Association/Reassociation relation to frame classes.

Dave Bagby
Advanced Micro Devices, Inc

31 August 1995

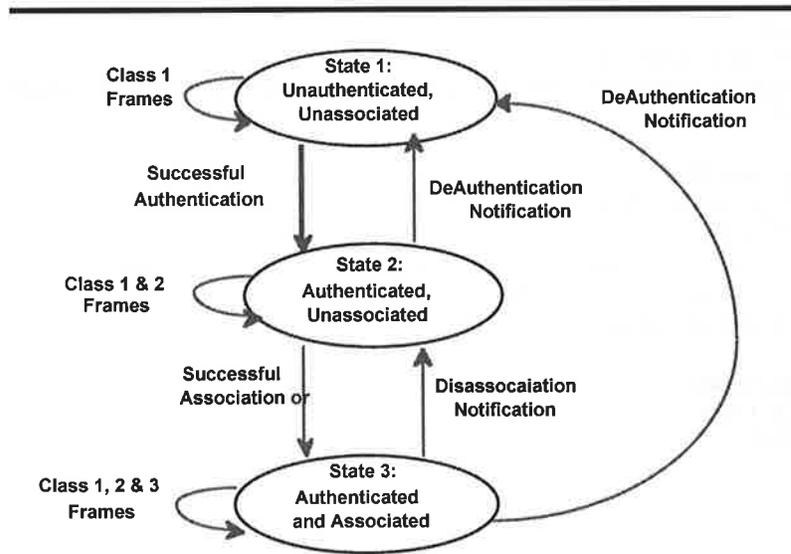
During the August 802.11 MAC meeting the group realized that there is an error in figure 2-8 which results in a catch-22 situation where it is necessary to be associated with an AP that a STA wants to reassociate to. This results from a confusion of the use of the term "association" to mean both the specific action accomplished by the Association frames and the generic class of actions comprised of both "association" and "reassociation". This paper corrects the figure and some related text.

Change label of transition from state 2 to state 3 in figure 2-8 above from "Successful Association" to "Successful Association or Reassociation".
